TOYOTA**PRODUCT SUPPORT DIVISION**

Volume: XIX
 Number: TC15-014
 Date: 4/8/2015
 Action
 Retain
 Information

To: All Toyota Region General Managers/Vice Presidents
 From: Bob Waltz 
 Group Vice President, Product Quality and Service Support
 Subject: Product Update F0M
 Certain 2011 Model Year Sienna Vehicles
 3rd Row Seat Back Panel Replacement

TECHNICAL INSTRUCTIONS
FOR
LIMITED SERVICE CAMPAIGN F0M
3RD ROW SEAT BACK PANEL REPLACEMENT
CERTAIN 2011 MODEL YEAR SIENNA

III. BACKGROUND

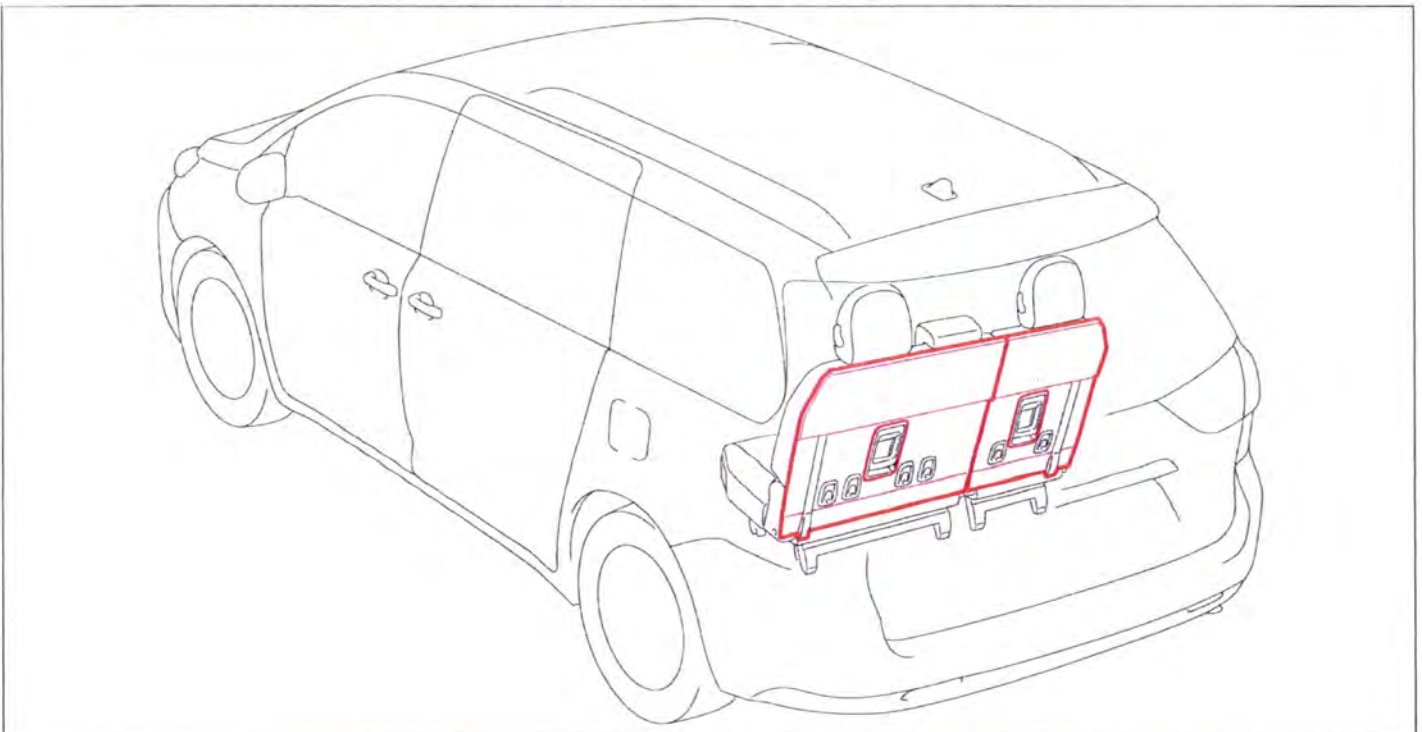
The 3rd row seat back panel contains instructions on how to stow and use the 3rd row seats. If the proper steps are not followed, users may have difficulty properly stowing or using the seats. Toyota has developed a new 3rd row seat fiberboard back panel containing larger labeling and sequenced instructions
